SUB-COMMITTEE ON DANGEROUS  
GOODS, SOLID CARGOES AND  
CONTAINERS  
18th session  
Agenda item 8

DSC 18/8/1  
14 June 2013  
Original: ENGLISH

## REVISION OF THE GUIDELINES FOR PACKING OF CARGO TRANSPORT UNITS

### Comments on the draft Code of Practice for Packing of Cargo Transport Units (CTU Code)

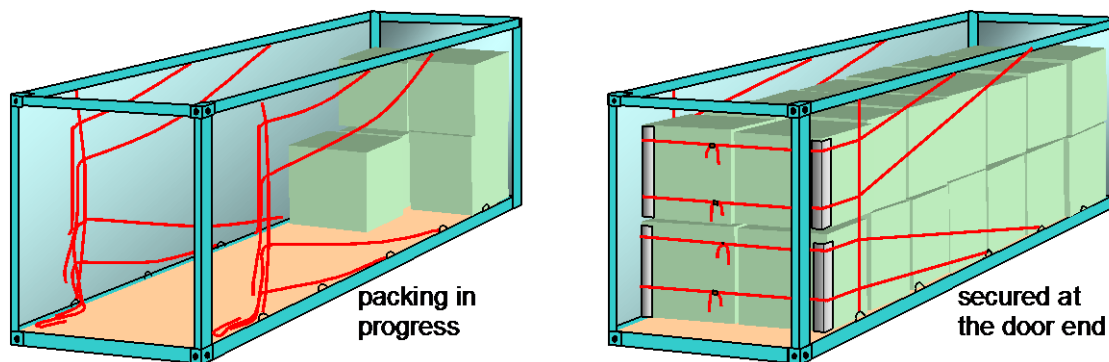
**Figure 14.20;** Change the figure to the following:

new Figure 14-22

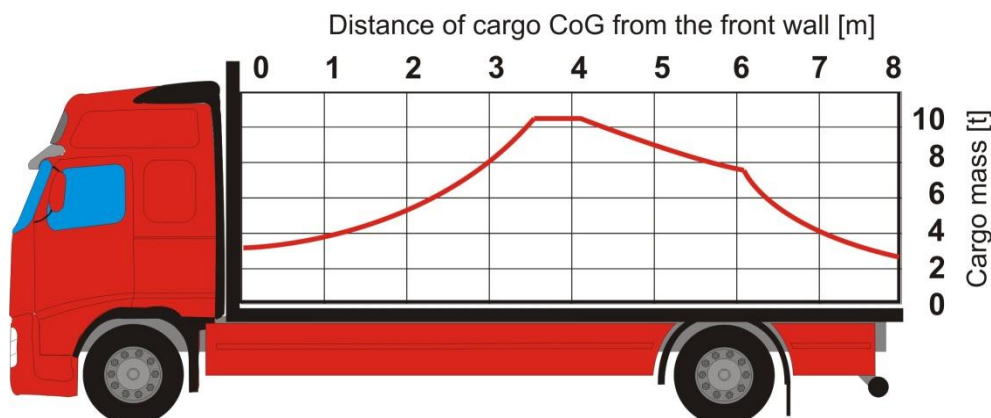
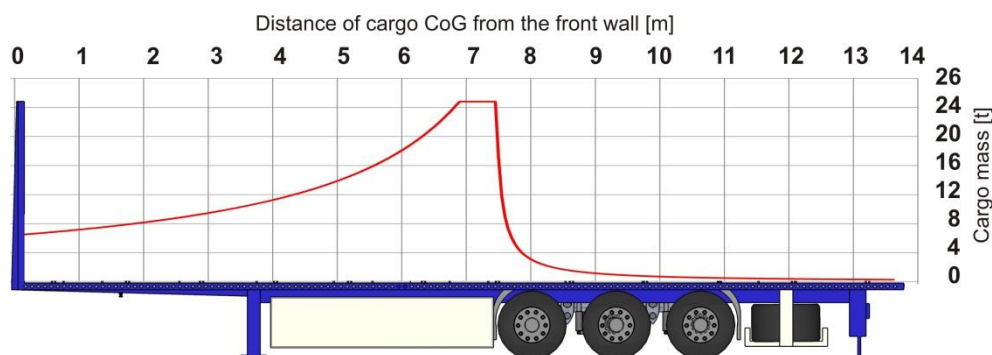
§ 3.1.7; **Figure 14-22, and Figure 14-23:** replace figures with following figures:

Figure 14.69 – Transverse battens in an ISO container

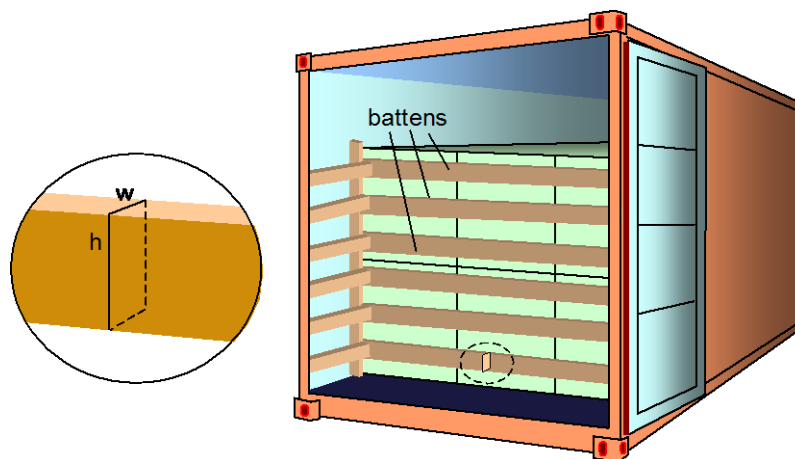
**Appendix 5**; Based on the tests and calculations the following text is proposed for aAppendix\_5 based on **option 2** for this section. When the formulas in this appendix have been agreed upon, user-friendly tables are proposed to be developed.

**1.1** The attainable resistance forces  $F$  of an arrangement of battens may be determined by the formula:

This force of 24 kN would be sufficient to restrain a cargo mass ( $m$ ) of 7.5 t, subjected to accelerations in sea area C with 0.4 g longitudinally ( $c_x$ ) and 0.8 g vertically ( $c_z$ ). The container is stowed longitudinally. With a friction coefficient between cargo and container floor of  $\mu = 0.4$  the following balance calculation shows:
